#### SOAH DOCKET NO. 473-23-21216 PUC DOCKET NO. 55067

APPLICATION OF ONCOR ELECTRIC	§	BEFORE THE STATE OFFICE
DELIVERY COMPANY LLC TO AMEND	§	
ITS CERTIFICATE OF CONVENIENCE	§	
AND NECESSITY FOR THE RAMHORN	§	OF
HILL - DUNHAM 345 KV	§	
TRANSMISSION LINE IN DENTON AND	§	
WISE COUNTIES	§	ADMINISTRATIVE HEARINGS

### EDGAR BRENT WATKINS AND MARY ANN LIVENGOOD'S FIRST SET OF REQUESTS FOR INFORMATION TO ONCOR ELECTRIC DELIVERY COMPANY, LLC

# Modified Segment V3 and Modified Segment V1

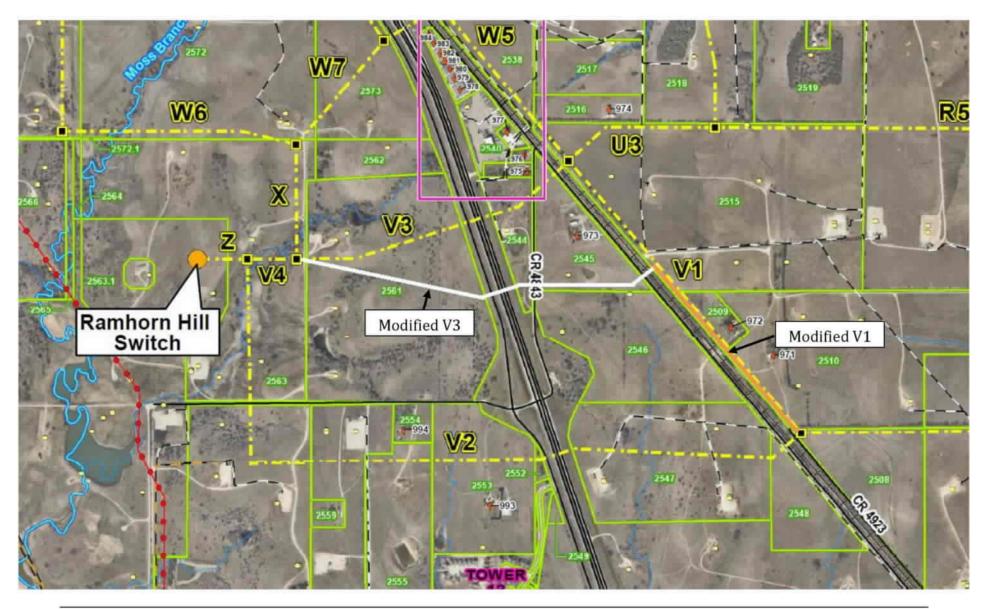
Watkins RFI No. 1-11. Using the proposed Modified Segment V3 (attached):

- a. Please provide an estimate of the cost difference and route evaluation criteria changes associated with modifying Segment V3 as depicted by the solid white line on the attached aerial image.
- b. Please confirm that any route using Modified Segment V3 instead of original Segment V3 would be viable, feasible, acceptable from an environmental and land use perspective, and conform to the Commission's policy of prudent avoidance. If you cannot so confirm, please explain why.
- c. Please confirm that using Modified Segment V3 would not require notice to any other landowners or any other owners of habitable structures. If you cannot so confirm, please explain why.
- d. Please provide updated cost estimates similar to Attachment 3 to the CCN Application for the routes that could utilize Modified Segment V3.

Watkins RFI No. 1-12. Using the proposed Modified Segment V1 (attached):

- a. Please provide an estimate of the cost difference and route evaluation criteria changes associated with modifying Segment V1, beginning at the intersection of Segments R4 and V1 and ending at the intersection of Modified Segment V3 and V1 as depicted on the attached aerial image.
- b. Please confirm that any route using Modified Segment V1 instead of original Segment V1 would be viable, feasible, acceptable from an environmental and land use perspective, and conform to the Commission's policy of prudent avoidance. If you cannot so confirm, please explain why.
